UNITED STATES
DEPARTMENT OF THE INTERIOR
BUREAU OF LAND MANAGEMENT
APPLICATION FOR PERMIT TO DRILL OR REENTER

1a. Type of work: <input checked="" type="checkbox"/> DRILL <input type="checkbox"/> REENTER 1b. Type of Well: <input checked="" type="checkbox"/> Oil Well <input type="checkbox"/> Gas Well <input type="checkbox"/> Other 1c. Type of Completion: <input type="checkbox"/> Hydraulic Fracturing <input checked="" type="checkbox"/> Single Zone <input type="checkbox"/> Multiple Zone		5. Lease Serial No. NMNM97127 6. If Indian, Allottee or Tribe Name 7. If Unit or CA Agreement, Name and No. 8. Lease Name and Well No. HONEY BUN 6 FED COM 706H 9. API Well No.

PECOS DISTRICT DRILLING CONDITIONS OF APPROVAL

OPERATOR'S NAME:	EOG RESOURCES INCORPORATED
WELL NAME & NO.:	HONEY BUN 6 FED COM 706H
SURFACE HOLE FOOTAGE:	309'/N & 819'/W
BOTTOM HOLE FOOTAGE:	230'/S & 2178'/W
LOCATION:	Section 6, T.26 S., R.27 E., NMP
COUNTY:	Eddy County, New Mexico

Proposed Wellbore
Design A

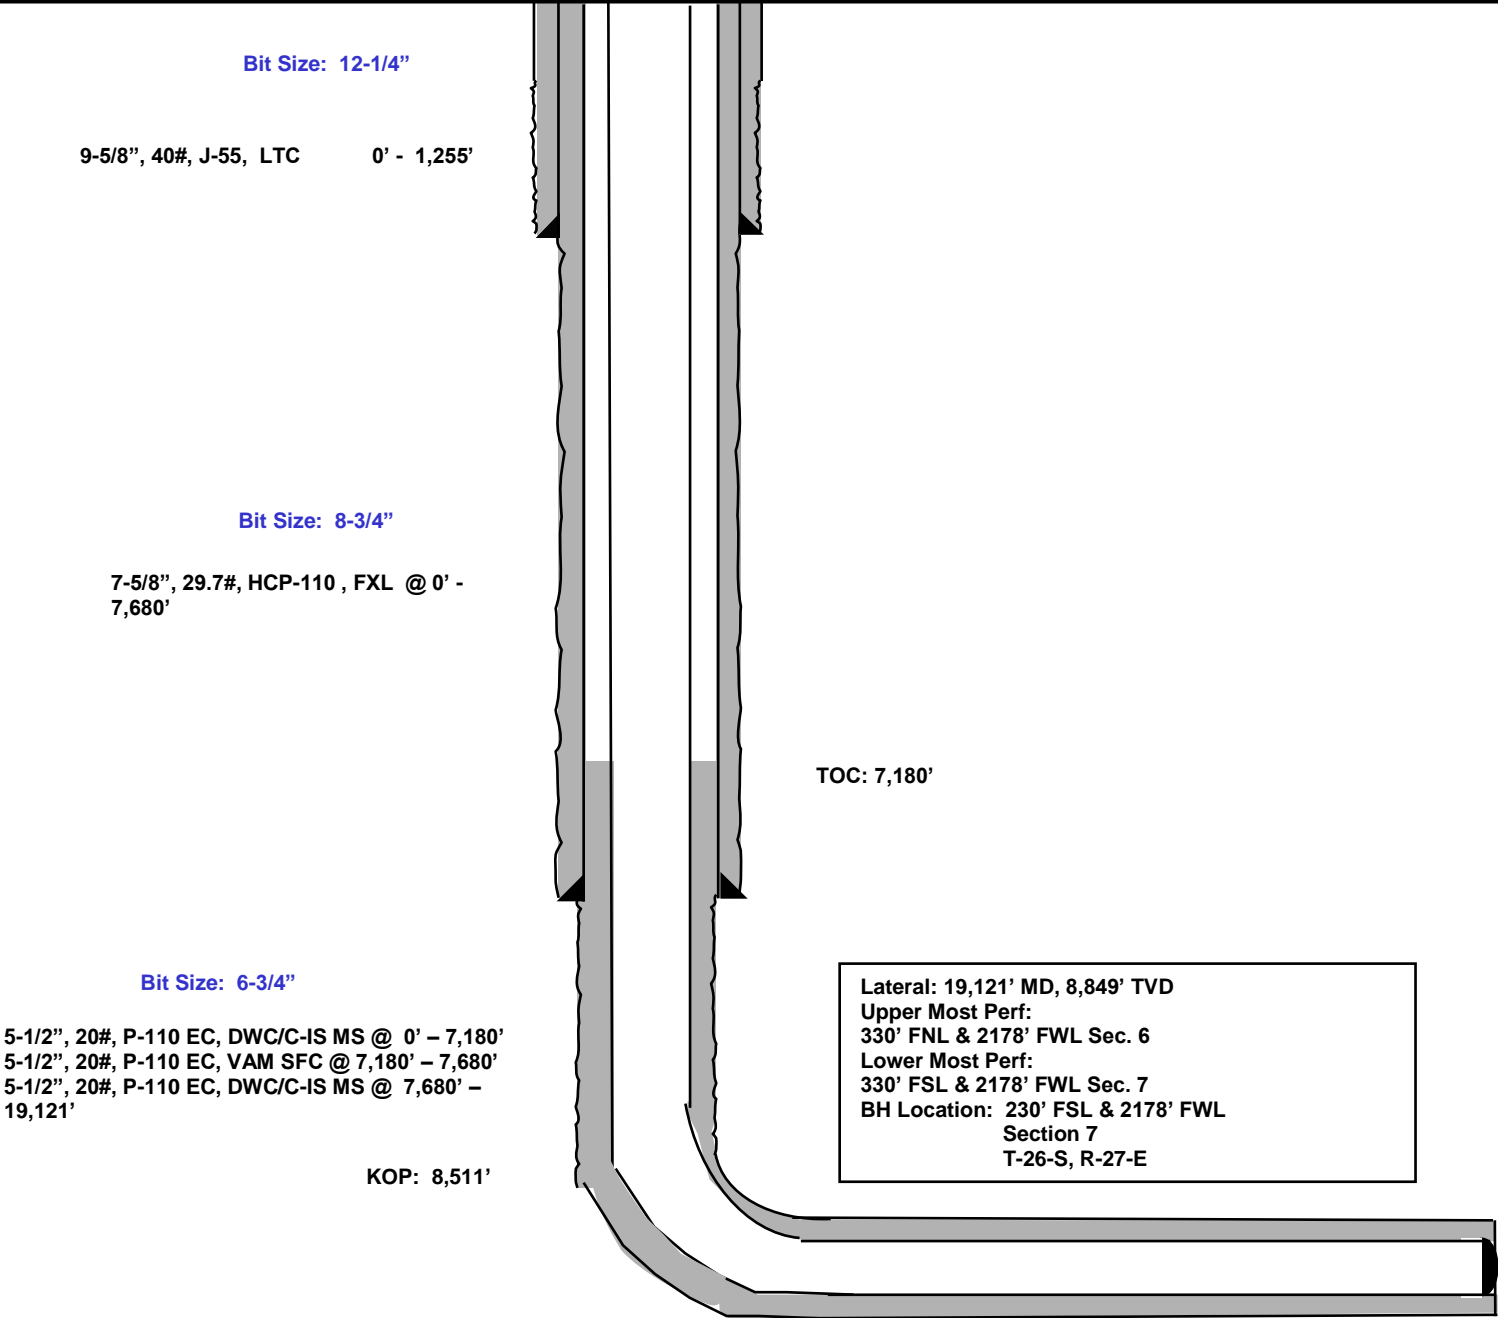
Operator has proposed to pump down 9-5/8" X 7-5/8" annulus after primary cementing stage. Operator must run Echo-meter to verify Cement Slurry/Fluid top in the annulus Or operator shall run a CBL from TD of the 7-5/8" casing to surface after the second stage BH to verify TOC.

3. The minimum required fill of cement behind the **5-1/2** inch production casing is:
 - Cement should tie-back at least **200 feet** into previous casing string due to operator not meeting casing clearance requirement per 43 CFR 3170. Operator shall provide method of verification.

Proposed Wellbore
Design B

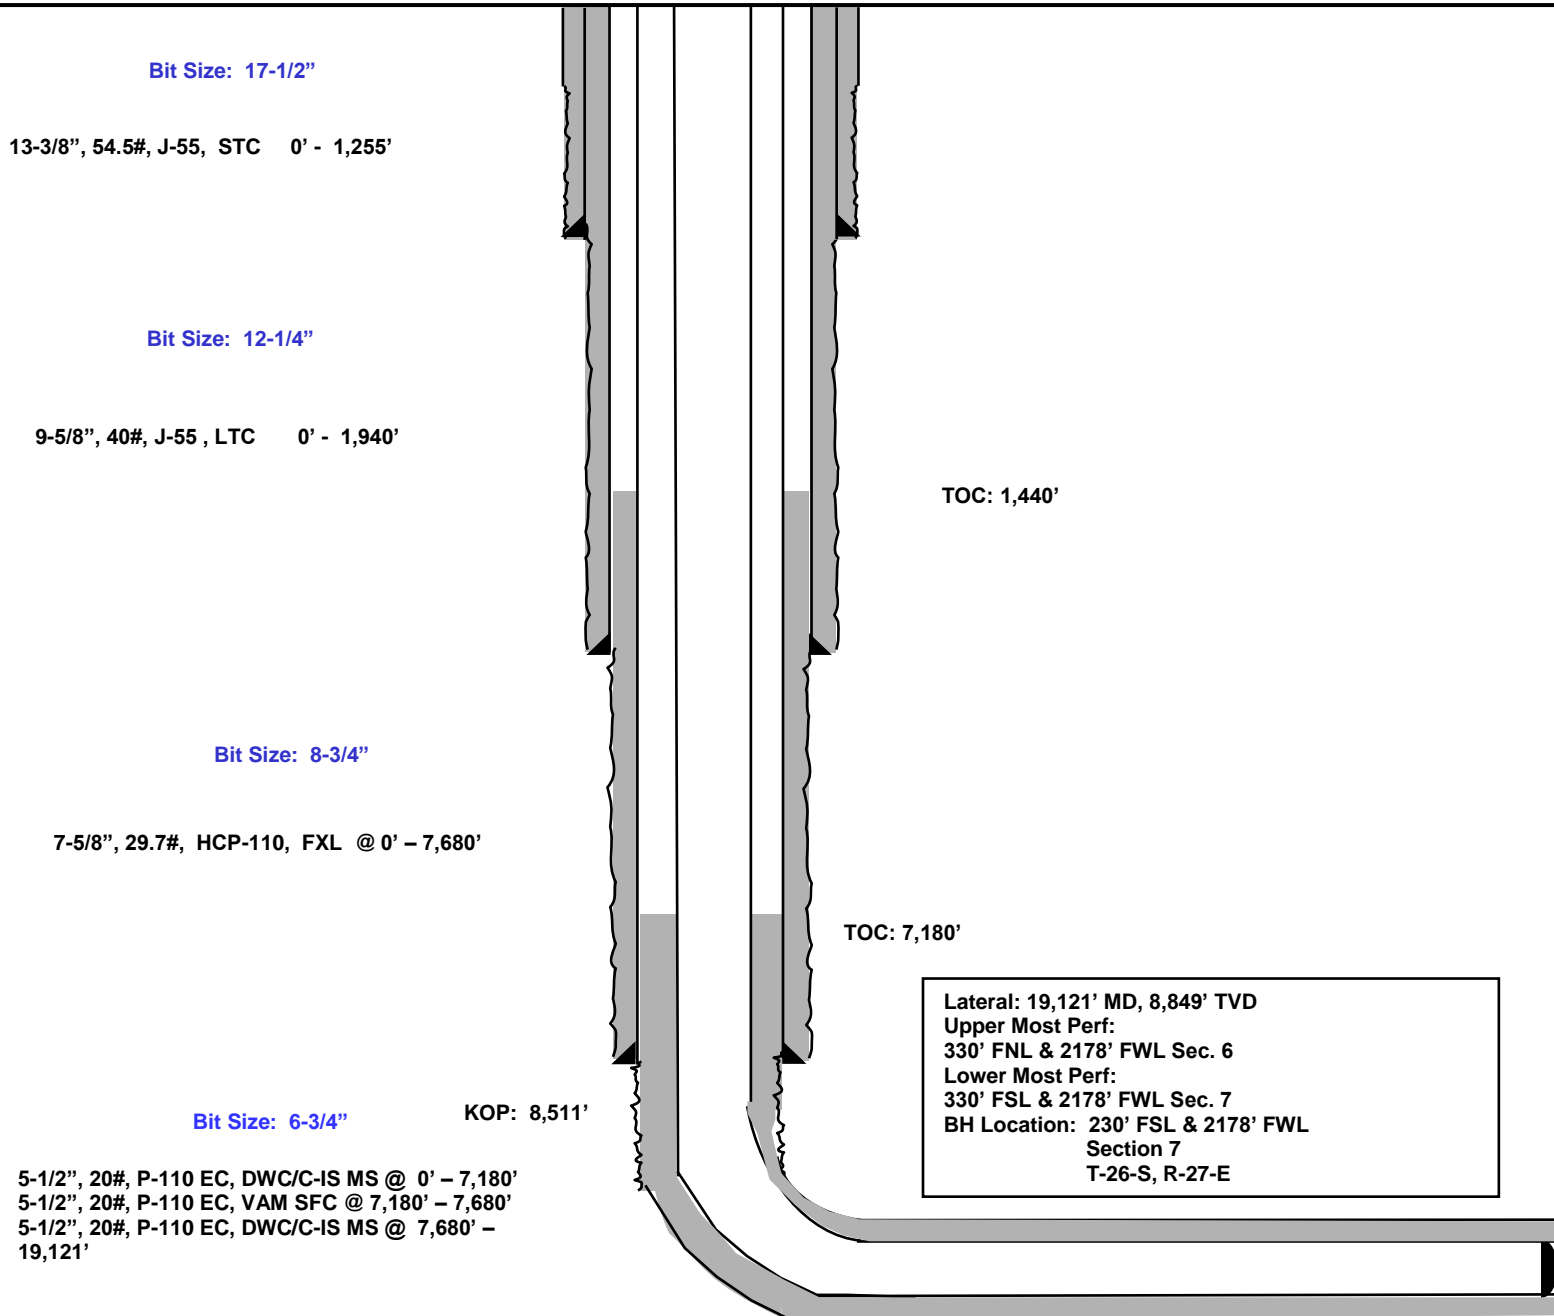
Operator is only approved for Design A. Design B is not to be utilized. If Design B is needed or any other change, please submit a NOI sundry to make the changes.
